ADAMSTOWN BOULEVARD PHASE 1

GRANT REF: SDZ22A/0007

INTRODUCTION - PLANNING CONDITIONS

This document is in response to Condition 7 and prepared by McCauley Daye O'Connell Architects.

3.3 HOUSE TYPE H3AB2 AMENDMENTS TO PLANNING APPLICATION

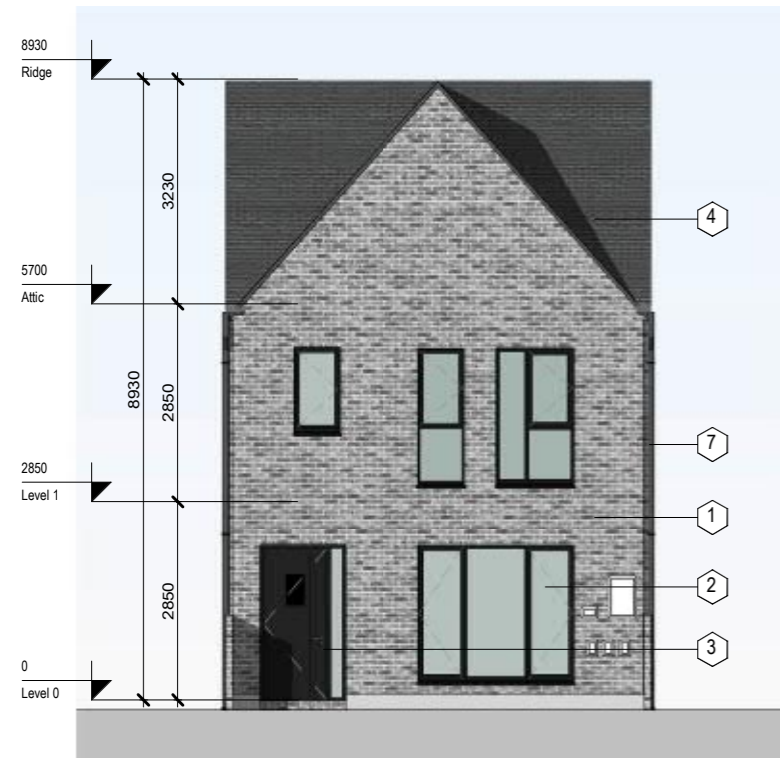
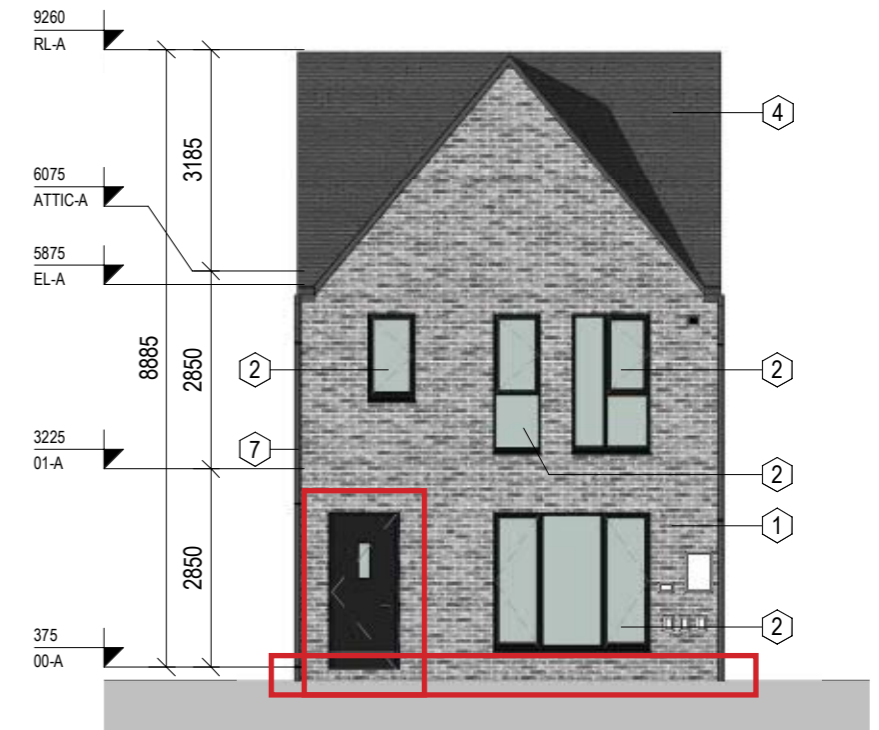
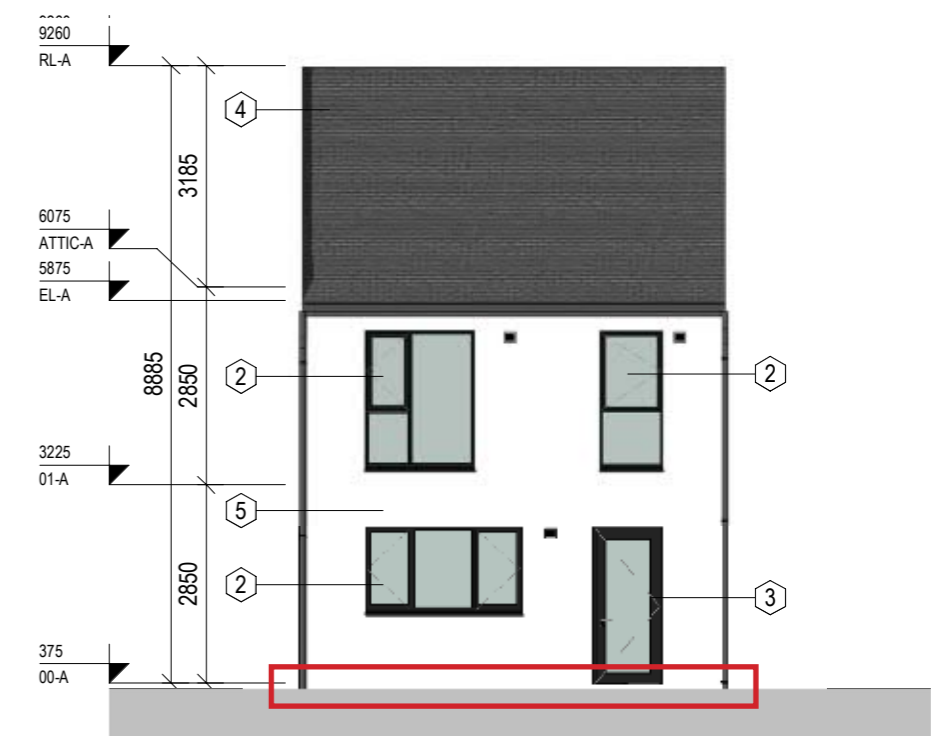
- Brick plinth introduced
- Plinth to rear removed
- Entrance door side panel removed
- Higher ridge level

3.4 HOUSE TYPE H3AC AMENDMENTS TO PLANNING APPLICATION

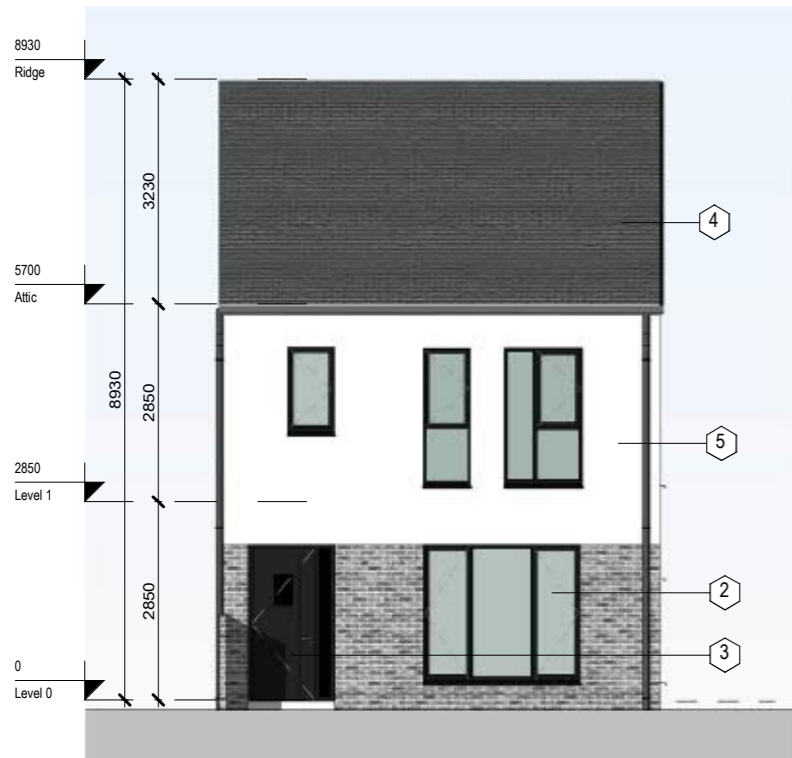
- Plinth to rear removed
- Entrance door side panel removed
- Lower ridge level

3.4 HOUSE TYPE H3AC AMENDMENTS TO PLANNING APPLICATION

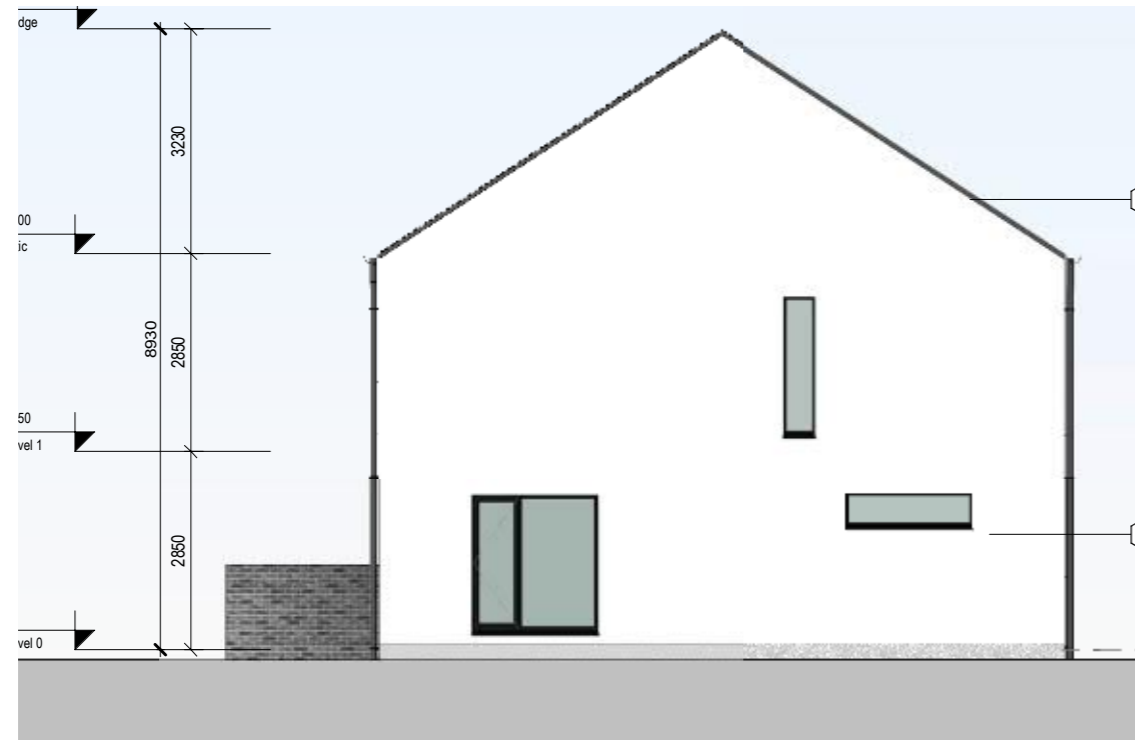
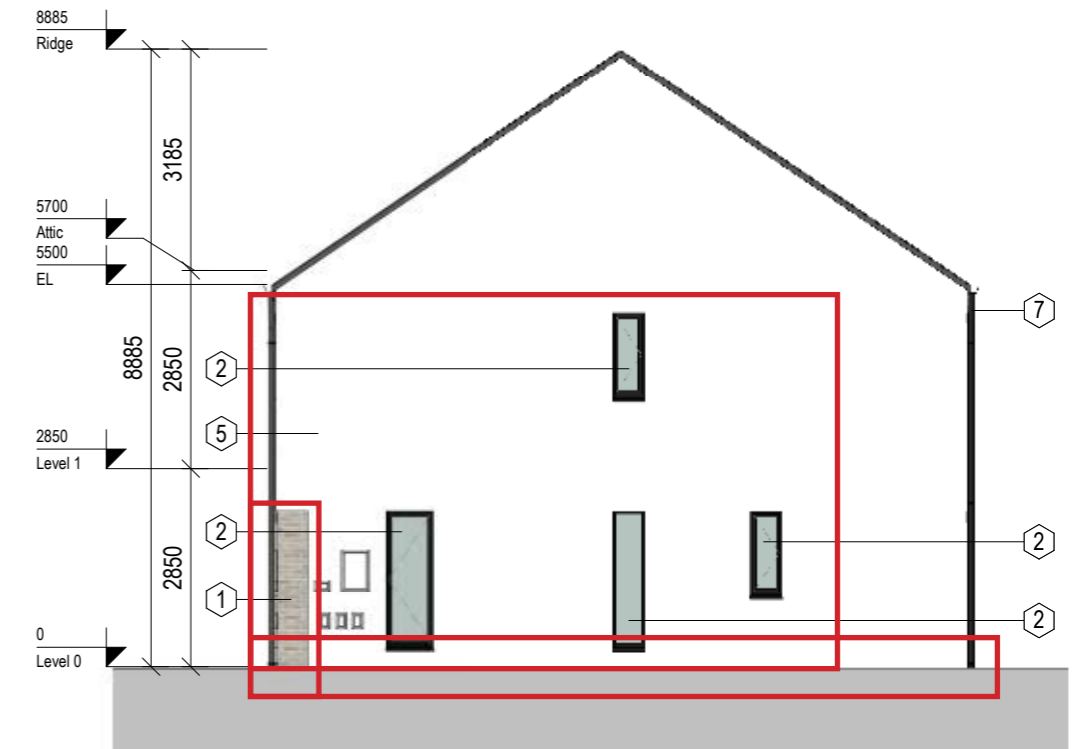
- Window type and position amended
- Plinth removed
- Brick wrapped around corner
- Lower ridge level

3.5 HOUSE TYPE H3AC1 AMENDMENTS TO PLANNING APPLICATION

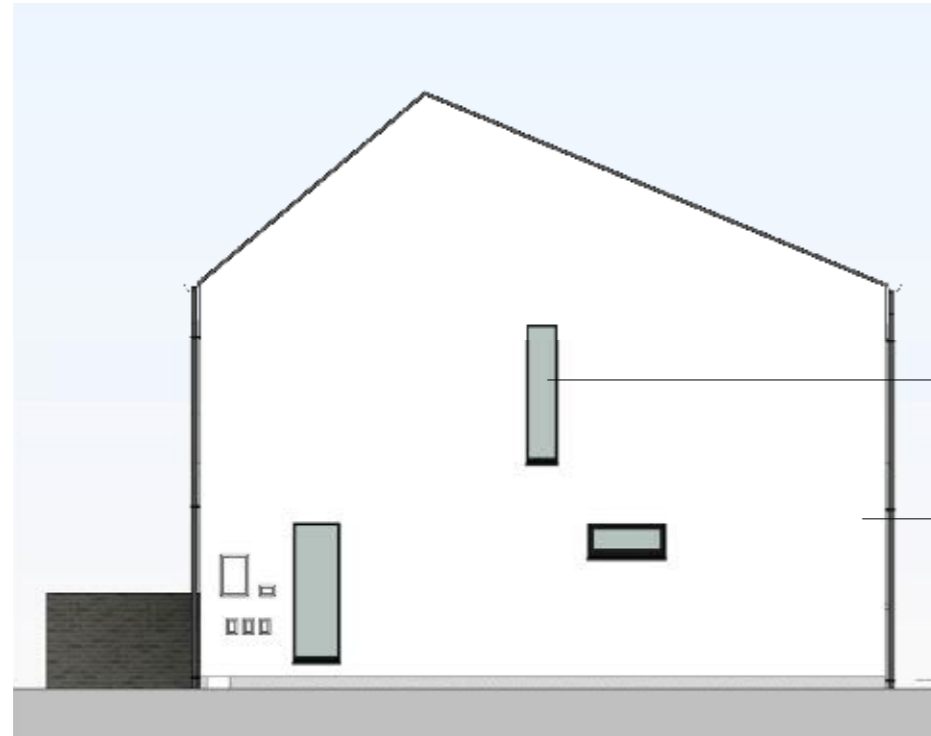
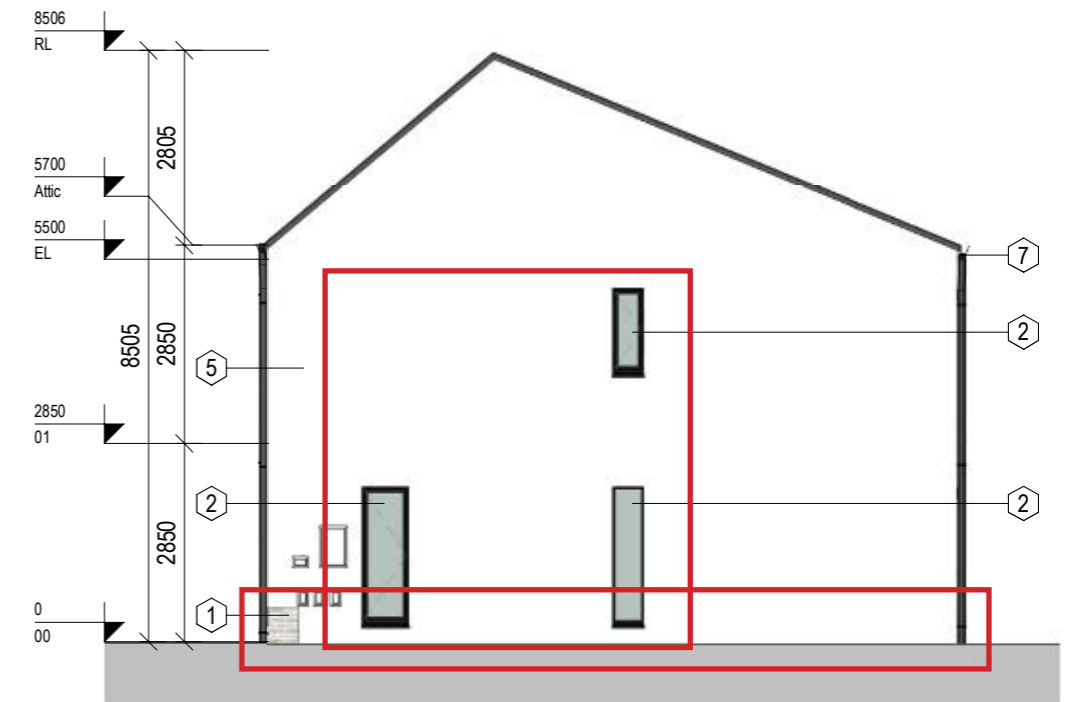
- Plinth removed
- Brick detail introduced
- Window type and position amended

3.9 HOUSE TYPE H3AD4 AMENDMENTS TO PLANNING APPLICATION

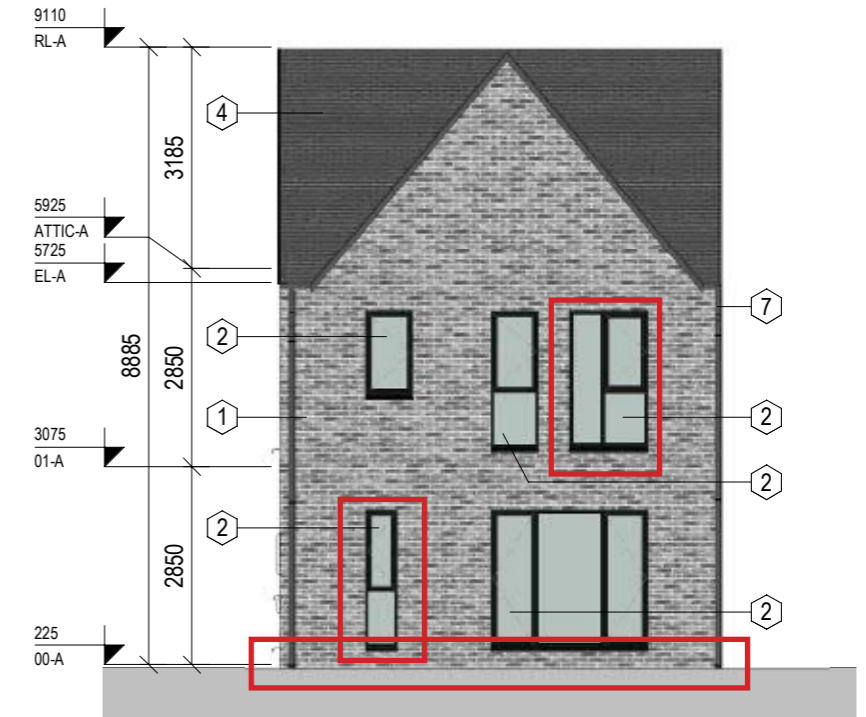
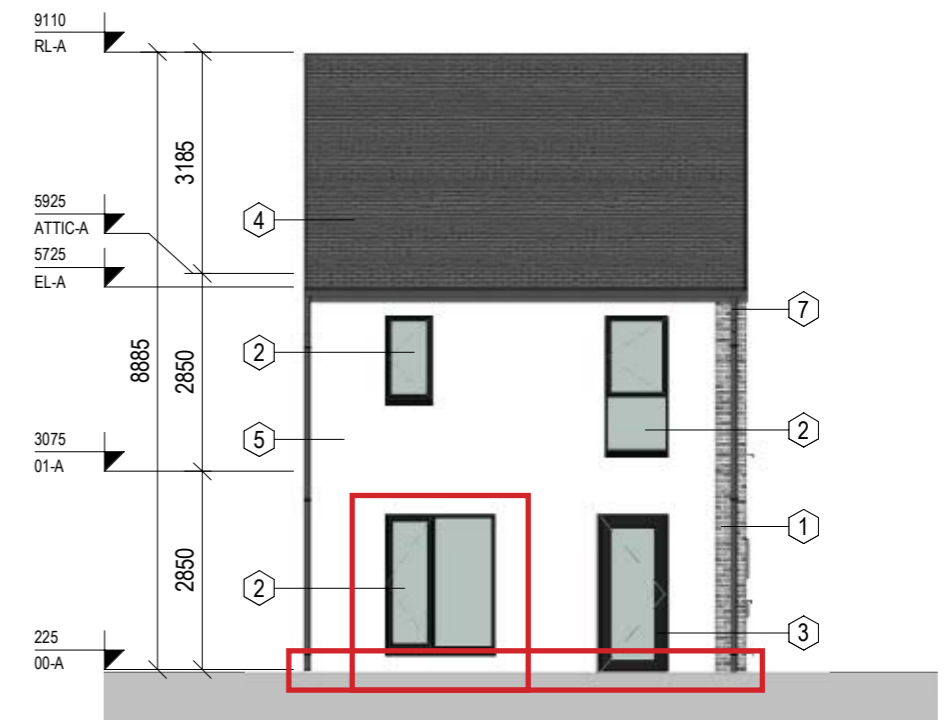
- Brick plinth introduced
- Plinth to rear removed
- Window type amended
- Higher ridge level

3.10 HOUSE TYPE H3BA AMENDMENTS TO PLANNING APPLICATION

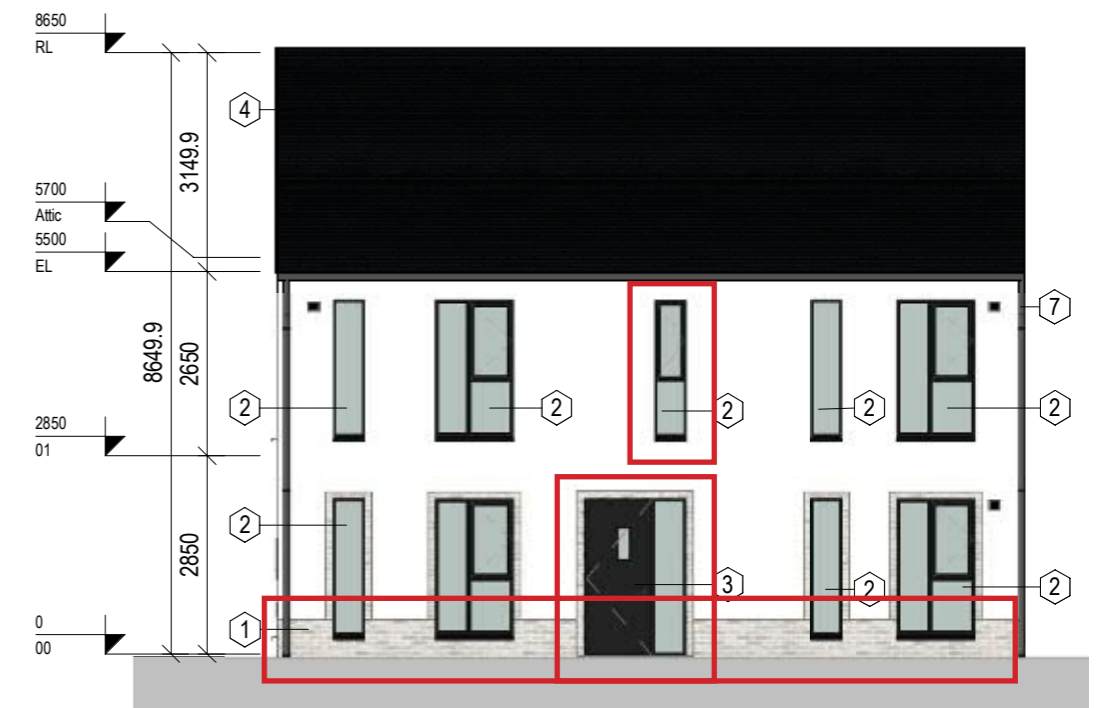
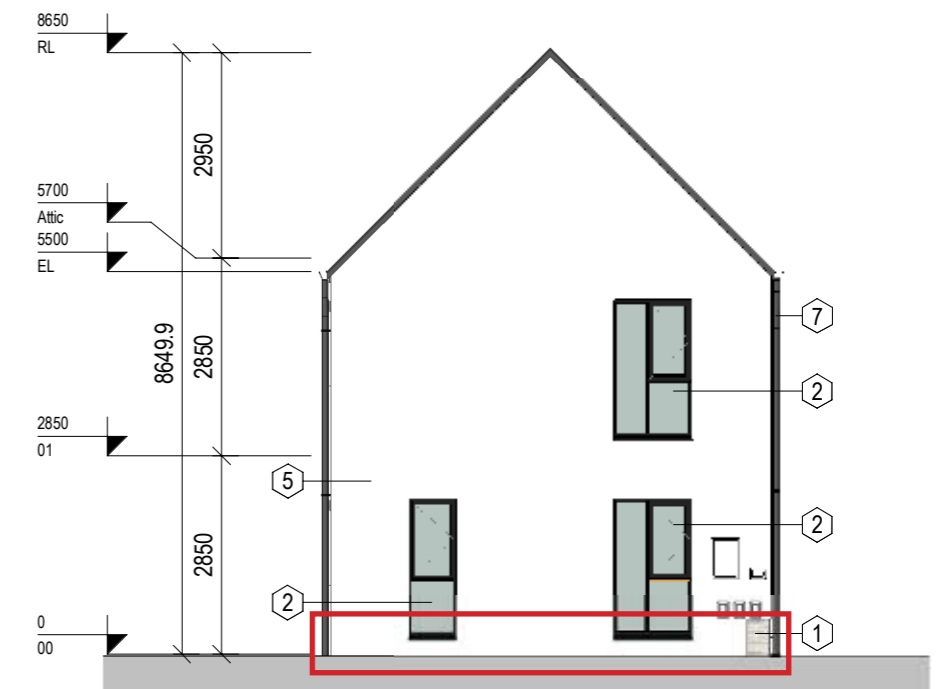
- Brick plinth amended
- Plinth to rear removed
- Window type amended
- Front door side panel enlarged
- Lower ridge level

3.11 HOUSE TYPE H3DB AMENDMENTS TO PLANNING APPLICATION

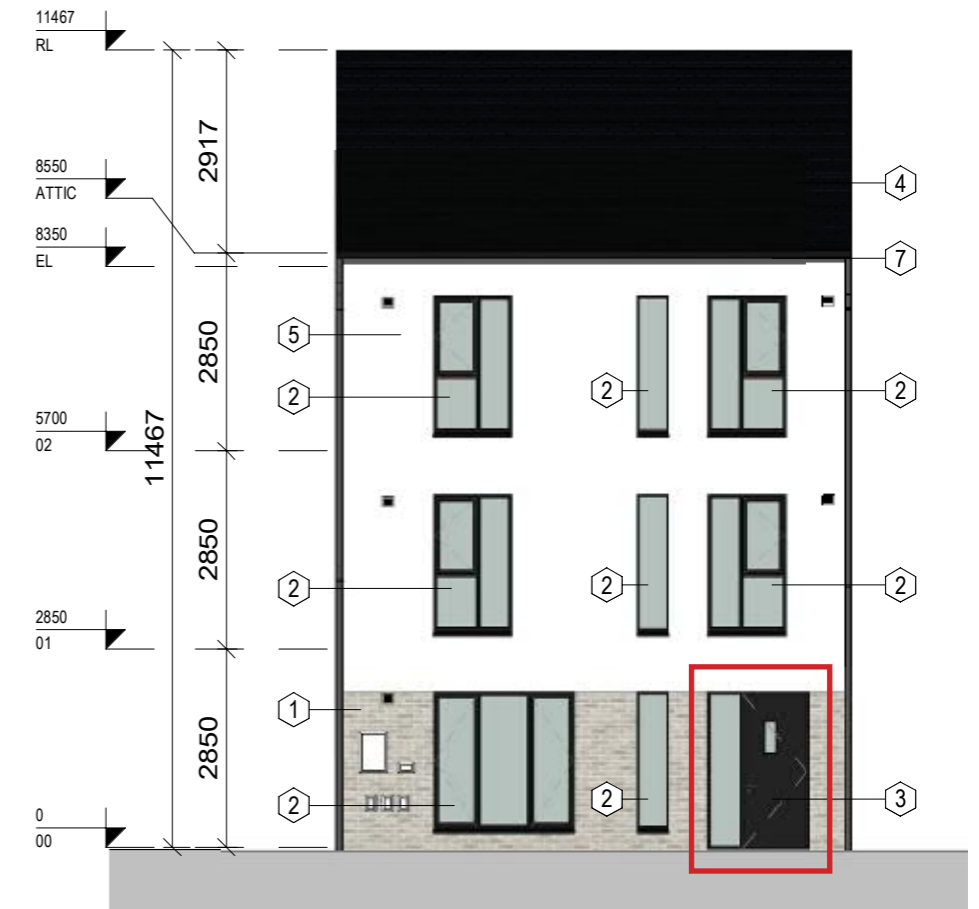
- Ridge level increased
- Entrance door type amended

3.11 HOUSE TYPE H3DB AMENDMENTS TO PLANNING APPLICATION

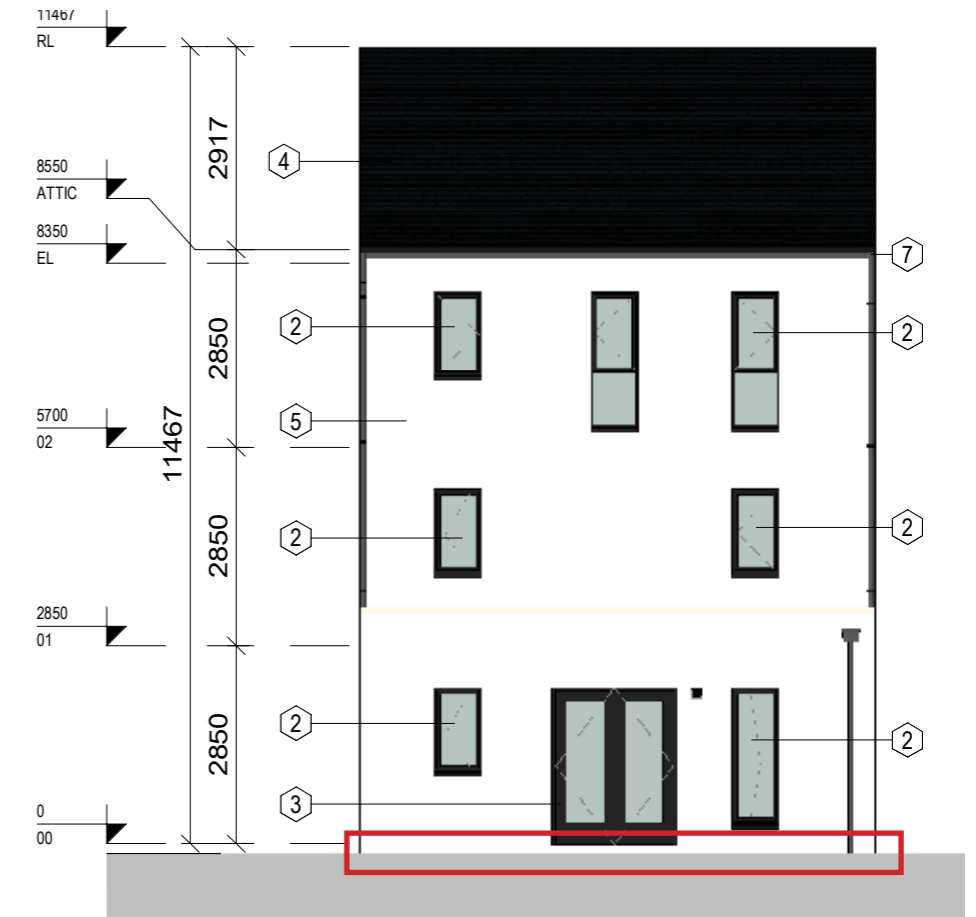
- Plinth to rear removed
